OBJECTIONS to planning application 2019/1653/P - 155 Drummond Street London NW1 2PB

As you will be aware, the planning application proposes the partial demolition of the existing four storey residential building at 155 Drummond Street and the erection of an eight-storey residential building.

APPENDIX 1 – DAYLIGHT OUTLOOK FROM FLAT 14

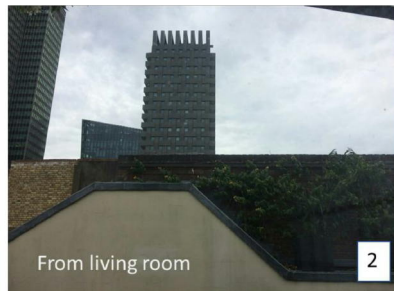
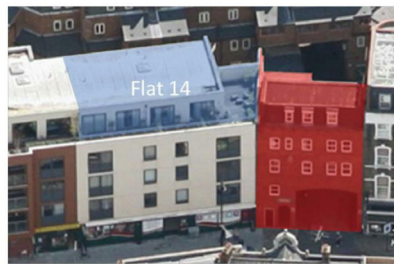
You will see from the images in Appendix 1 of this letter that Flat 14 has a roof terrace, the western wall of which is approximately 2m at its highest point and is part of a party wall with 155 Drummond Street.

You will also see that [REDACTED] roof terrace and the western facing windows of his living room and bedroom currently benefit from high levels of daylight and afternoon sunlight.

The sections of the proposed scheme shown on the application drawing P.23 indicate that the proposed development will increase the height of the western wall across its entire length by some 11m-12m. This will obviously block out a large proportion of the **daylight and afternoon sunlight** currently received by [REDACTED] roof terrace and the western facing windows of his living room and bedroom.

It will also be a hugely **overbearing presence** for users of the roof terrace and when viewed from these windows, severely impacting the current open outlook.
